Product Change Notification: P-15-012042

090 SLD 3P Plug Assy (PN: 936251)

✓ 090 SLD 3P PLUG HSG (PN:936252)

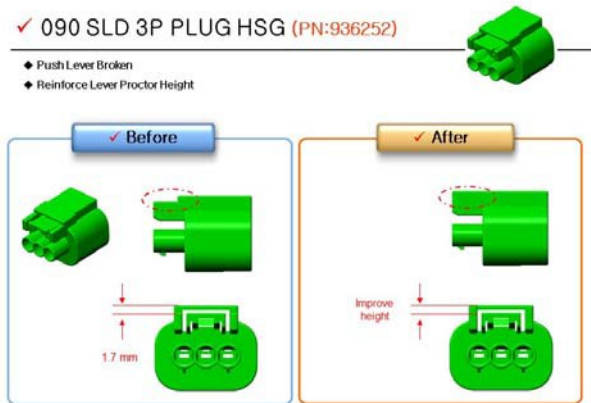
Reinforce for protector guide on the plug housing. the protector guide height will increase.

- ◆ Push Lever Broken
- ◆ Reinforce Lever Protector Height
